TECHNICAL NOTE

Job Name: Lynsted Lane, Teynham
Job No: 332410730
Note No: TN02
Date: 9th May 2022
Prepared By: Gareth Elphick
Subject: Land off Lynsted Lane, Teynham (planning ref: 21/502609/OUT) - Response to Project Centre Report (1000007836)

Appendix A Stantec Drawing 49905_5501_005E – updated to confirm visibility splays and SSD

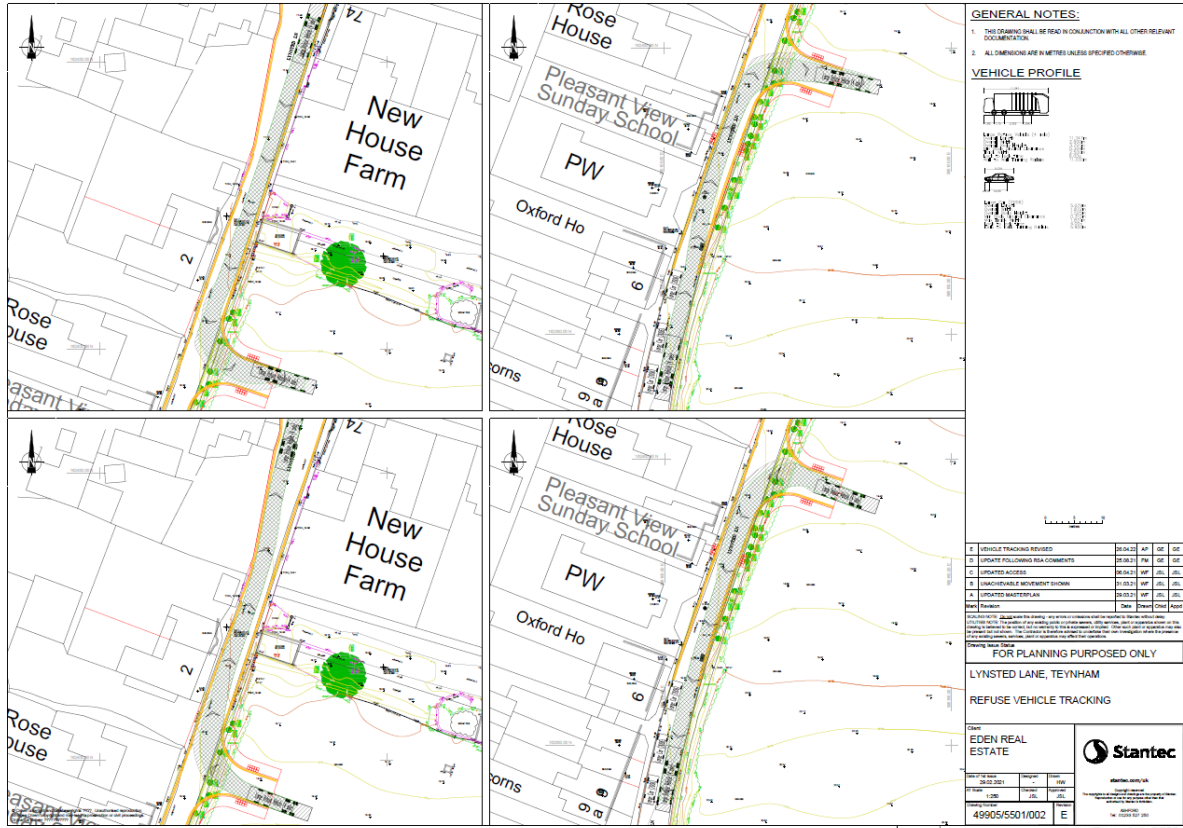
'Determine the extent of parking restrictions required on Lynsted Lane, so that visibility is not obstructed at the site access. We note this should be included on the revised layout for Lynsted Lane which proposes give way controls on Lynsted Lane,'

'Demonstrate that suitable SSD can be achieved on approach to the Lynsted Lane give way control'

- 2.9. Please see updated drawing 49905/5501/005E which has confirmed visibility splays and SSD. These meet the requirement of Manual for Streets (MfS), Kent Design Guide and also considered DMRB CD109. The SSD is shown as 70m, using DMRB for a 30mph/50kph road but this is a robust overapplication, and 43m is sufficient commensurate with the agreed approach with KCC Highways for the site access visibility splays (as per MfS and 30mph). This approach itself is deemed particularly robust because the nature of the road, parked cars and approaching/leaving a junction would result in a speed under the 30mph posted.

LYNSTED LANE, TEYNHAM
PARKING BEAT SURVEY

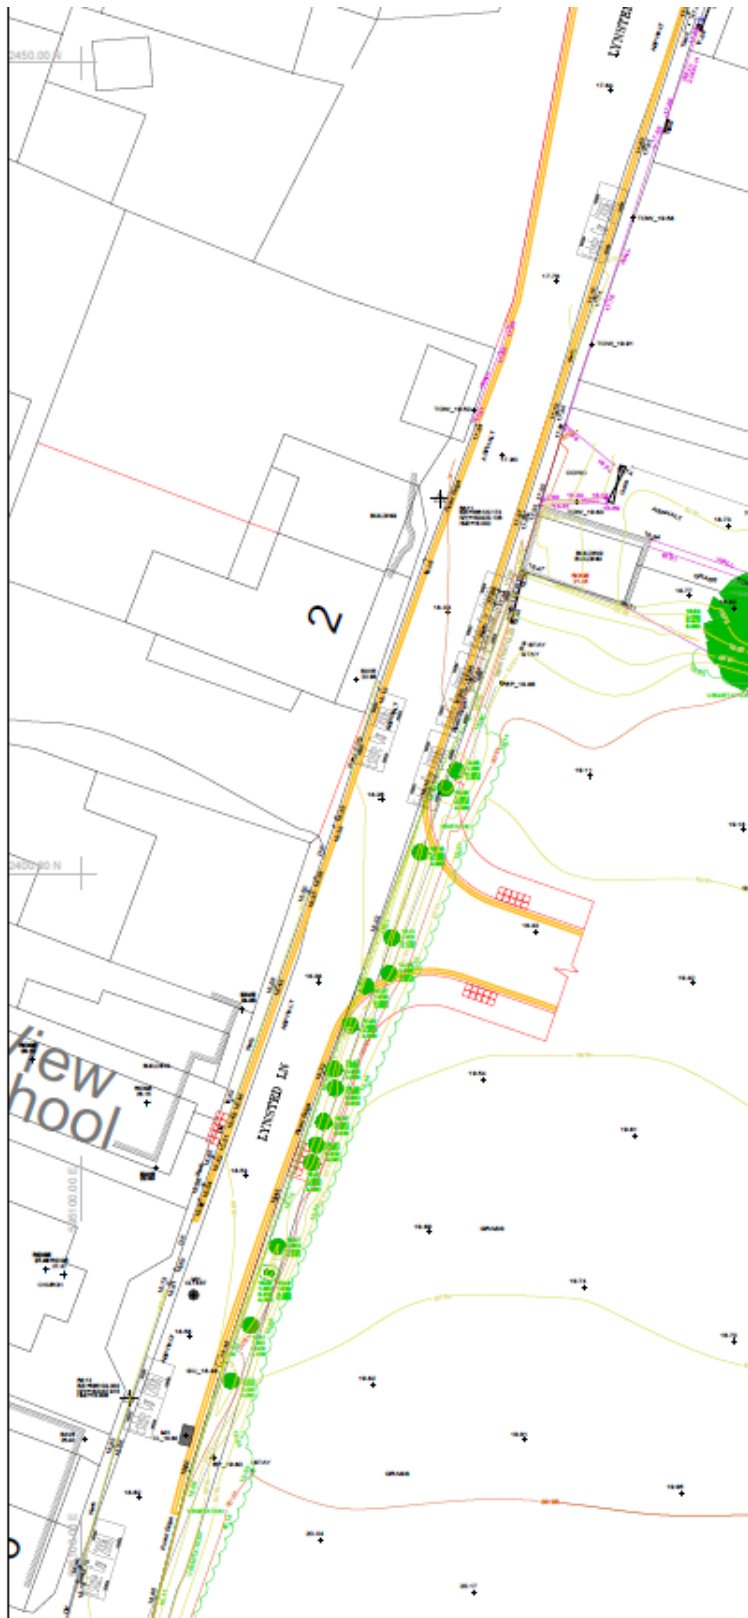
'The proposed double yellow lining should extend for the full length of the required SSD visibility splay,'³ 'notably to the south on the eastern side of Lynsted Lane, to ensure visibility splays are not obstructed.'

'Demonstrate that any loss of parking on Lynsted Lane can be accommodated elsewhere along the road, within a suitable walking distance.' 'Overspill parking within the site boundary, as proposed by the applicant should be secured as part of a planning condition.'

- 2.12. In terms of extending the yellow lining to the south on the eastern side of the road (access visibility splay side), as suggested as the most pertinent, this is clearly not problematic but is also likely unnecessary as parking alongside the hedgerow is unlikely and not witnessed in the parking beat survey. Nonetheless Drawing 49905_5501_004 has been updated to so show this extra 'eastern side' lining. This drawing is appended (49905_5501_004B)
- 2.13. Stantec would also likely reaffirm that the design approach to the south had been 'corner-protection', and this had been deemed sufficient in previous dealings with KCC Highways and the Road Safety Auditor.

- 2.19. In terms of additional parking spaces within the site, the outline application, which is informed by the Transport Statement and Parking Beat Survey (accepted by KCC Highways and SBC as accurate) suggests 3 compensation spaces are appropriate. Please refer to drawing 49905_5501_004 within the application documentation (appended to this document for convenience)

- 2.24. For convenience the parking beat survey plans that were presented in the TS (as Appendix D) have been reappended. In addition to any compensation parking provided within the site, circa 10 spaces are available south of the promoted double yellow lines, which provides parking within a reasonable walking distance of any lost 'potential' parking. As shown above parking stress of well below 90% is noted on Lynsted Lane.
